寄件者: Tang Lok San <[REDACTED]>
寄件日期: 2026年08月25日星期二 15:18
收件者: tpbpd/PLAND
主旨: Re: S. 16 Planning Application No. A/YL-KTN/1246 - Departmental Comments
附件: AYL-KTN 1246 20260807.pdf

有關漁農自然護理署對 A/YL-KTN/1246 的查詢

Appendix 7 Statutory Plans	Location: D.D. 107 Lot 1292 OZP: S/YL-KTN/11 District: Kam Tin North Zoning: Agriculture	Proposed Temporary Warehouse (excluding Dangerous Goods Godown) with Ancillary Facilities and Associated Filling of Land For a Period of 3 Years		Drawing No.: 7
				For Identification Only Date: 07/08/2026

Responses on DSD's Requirements and RemindersPlanning Application No.: A/YL-KTN/1246Location: Lot No. 1292in D.D. 107Site Area: 647.5 m²Land filling works involved? Yes / NoMaximum increase in formation level: 0.6 mMaximum level difference with adjoining lot: 0 mFilling of pond(s) involved? Yes / NoEstimated size of pond to be filled: NA m³

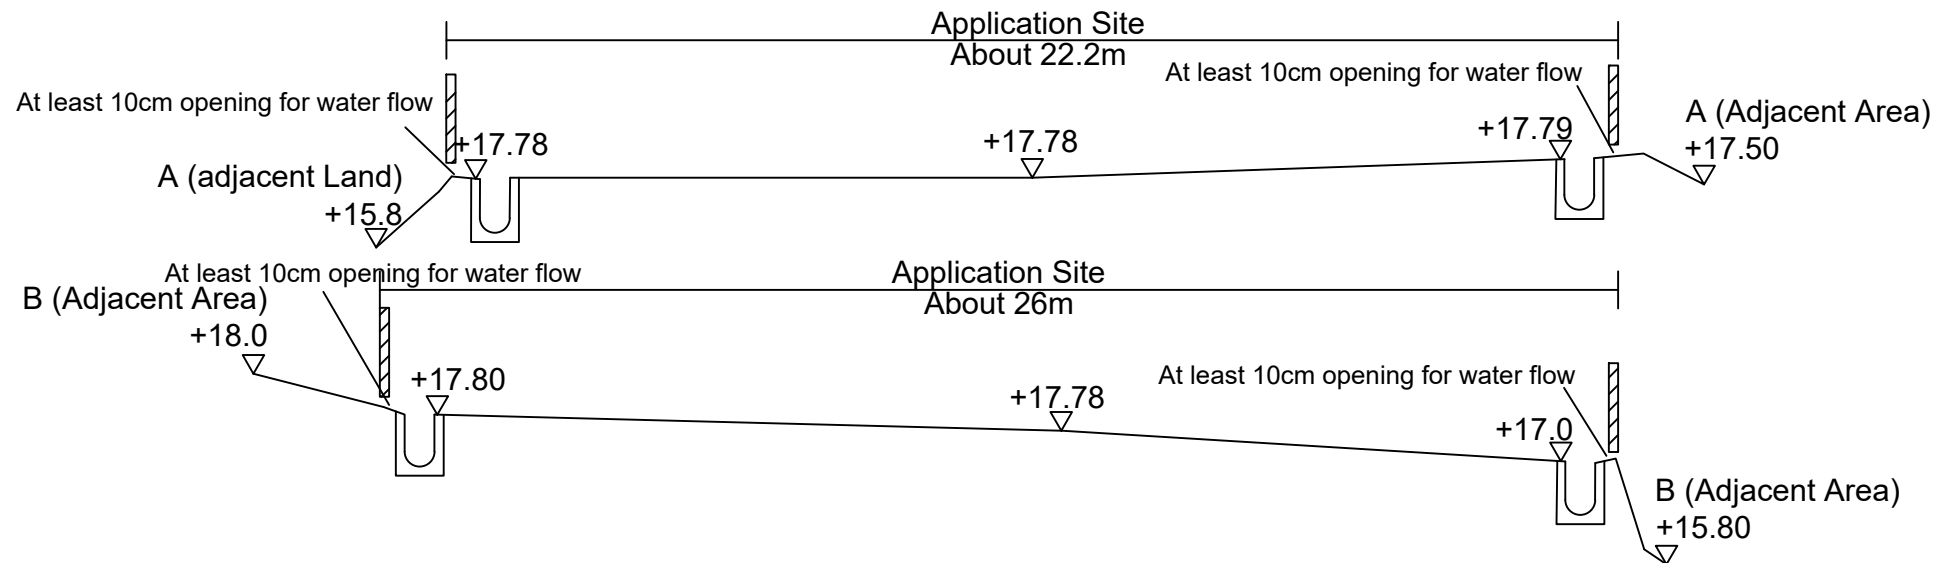
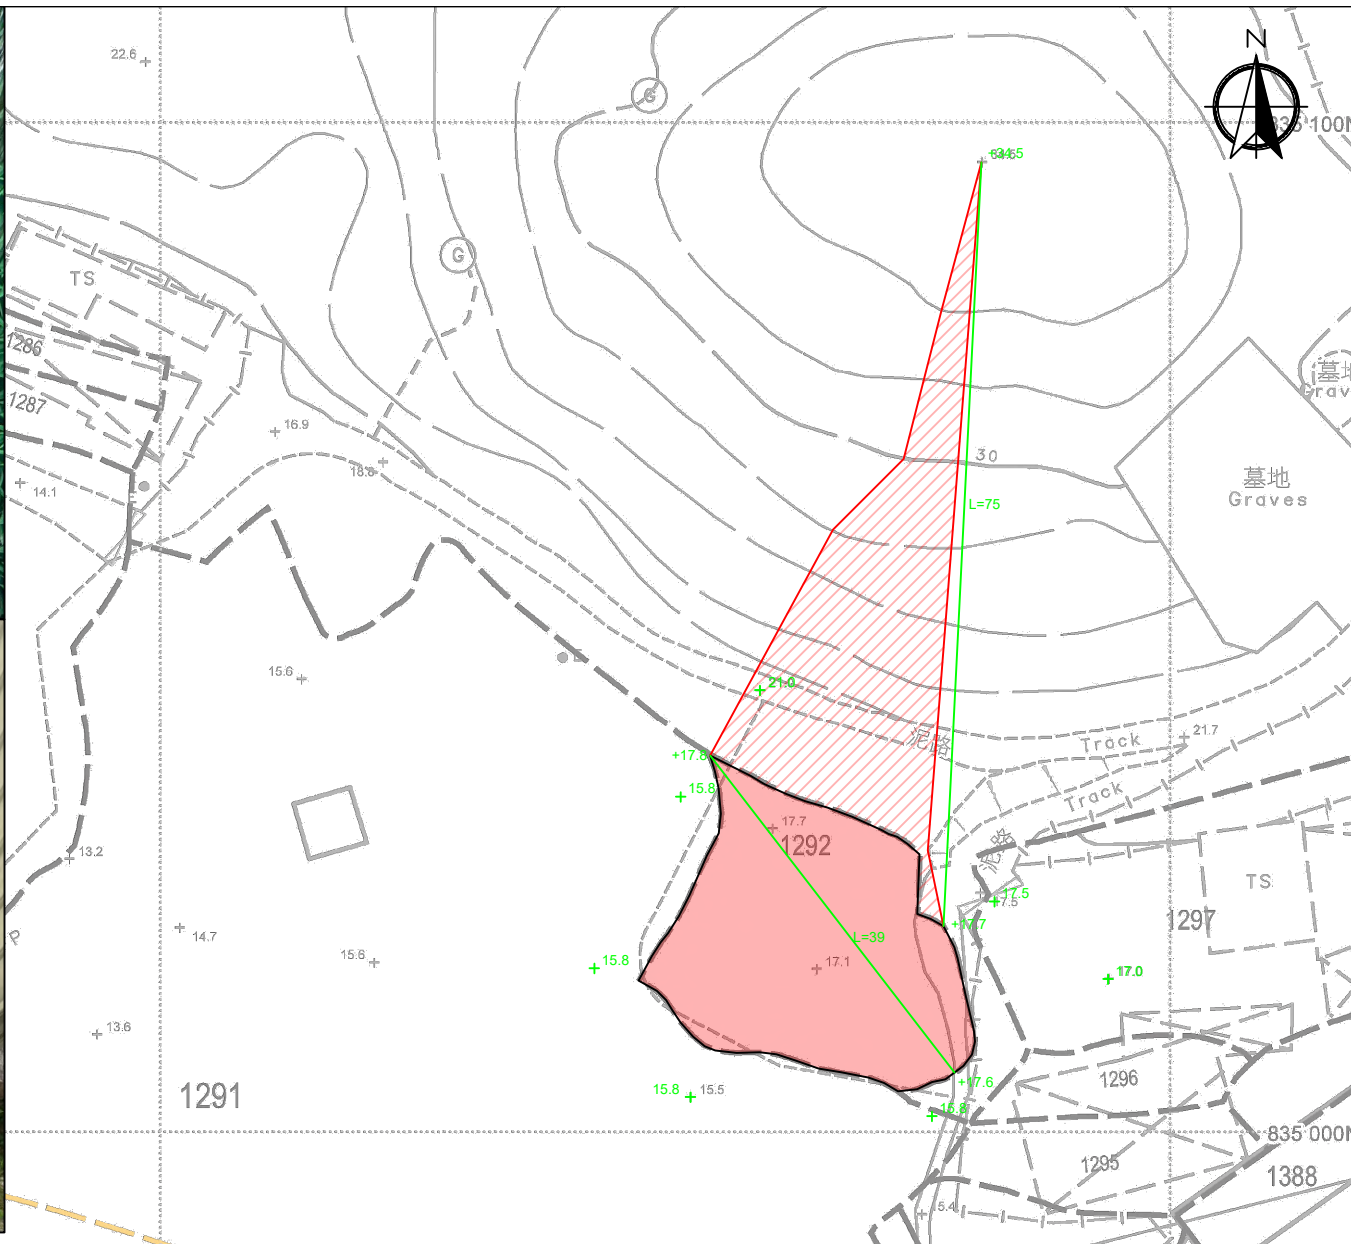
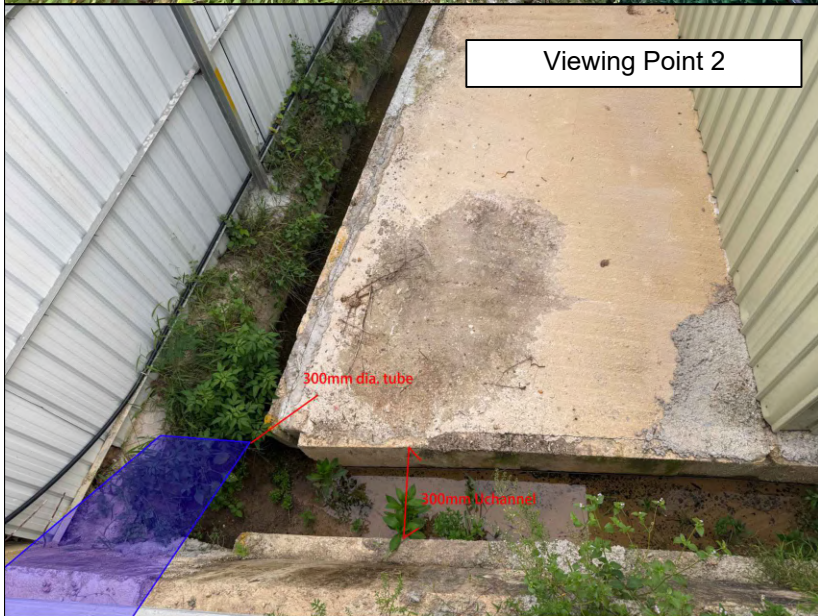
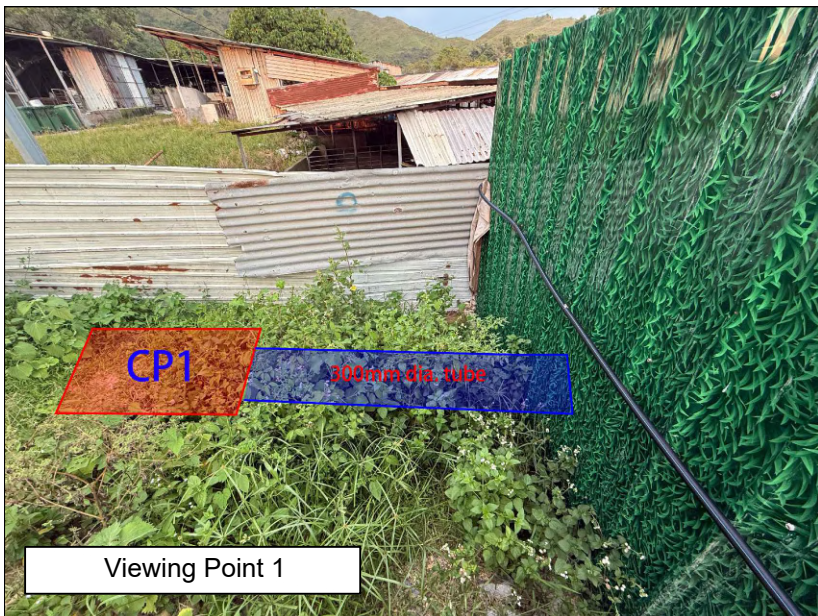
8	Cross sections showing the proposed drainage facilities and existing and proposed ground levels of the application site with respect to the adjacent areas should be given.	Yes
9	The proposal should indicate how the runoff (the flow direction) within the site and from the adjacent areas would be discharged to the proposed drainage system.	Yes
10	Sand trap or provision alike should be clearly indicated on the proposed drainage plan and provided before the collected runoff is discharged to the existing drainage facilities.	Yes
